PRODUCT CHANGE NOTIFICATION

Bourns® Model SRU5028A Series Shielded Power Inductors

Manufacturing Site Relocation and Changes to Processes and Ink Supplier

IC24080

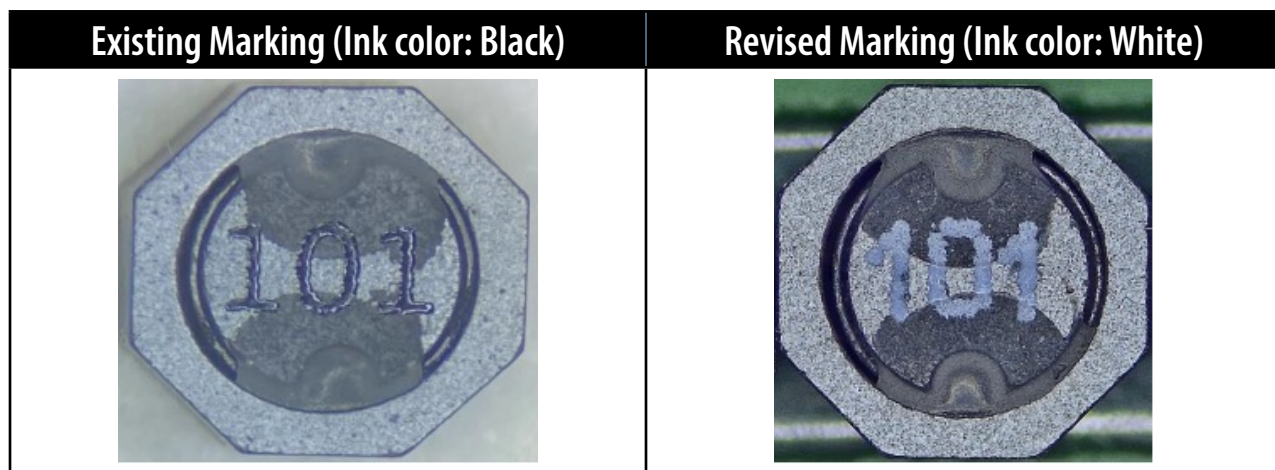
Bourns will also change its marking, testing, and taping processes into one integrated automated process for these inductors. The marking process will change from screen printing to inkjet printing, the ink color will change from black to white, and the ink supplier will also change. These changes should improve production efficiency, product quality, and reliability. The new supplier has been qualified and is included in the Bourns Authorized Vendor List. A list of affected part numbers is included below.

As shown in the images on page 1, the form will change slightly due to changes in the marking process and ink. The fit, function, reliability, quality and country of origin of the affected part numbers will remain the same. Traceability will be maintained through lot code and date code.
